**THE SERVICED GRID CODE – ISSUE 5 REVISION 14**

Issue 5 Revision 14 of the Grid Code has been approved by the Authority for implementation on **26 August 2015**.

## **THE GRID CODE – ISSUE 5 REVISION 14**

#### **GC0076 – Grid Code Limits on Rapid Voltage Changes**

Figure CC.6.1.7 -  
Time and magnitude limits for a category 3 Rapid Voltage Change

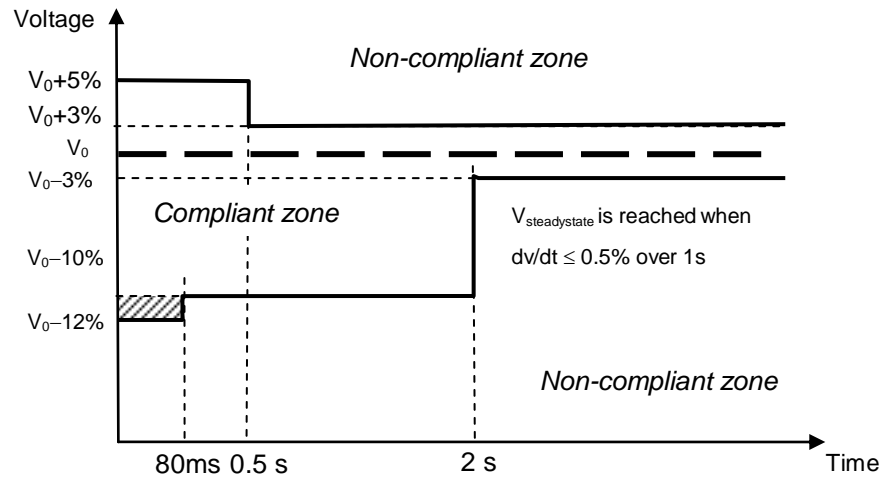
This proposal describes modifications to the Grid Code limits on the Rapid Voltage Changes which can occur because of planned Transmission system and Transmission User operations.

- (vii) Voltage changes in category 3 do not exceed the limits depicted in the time dependant characteristic shown in Figure CC.6.1.7;
- (viii) Voltage changes in category 3 only occur infrequently, typically not planned more than once per year on average over the lifetime of a connection, and in circumstances notified to **NGET**, such as for example commissioning in accordance with a commissioning programme, implementation of a planned outage notified in accordance with **OC2** or an **Operation** or **Event** notified in accordance with **OC7**; and

<sup>1</sup> A decrease in voltage of up to 12% is permissible for up to 80ms, as highlighted in the shaded area in Figure CC.6.1.7, reducing to up to 10% after 80ms and to up to 3% after 2 seconds.

<sup>2</sup> An increase in voltage of up to 5% is permissible if it is reduced to up to 3% after 0.5 seconds.
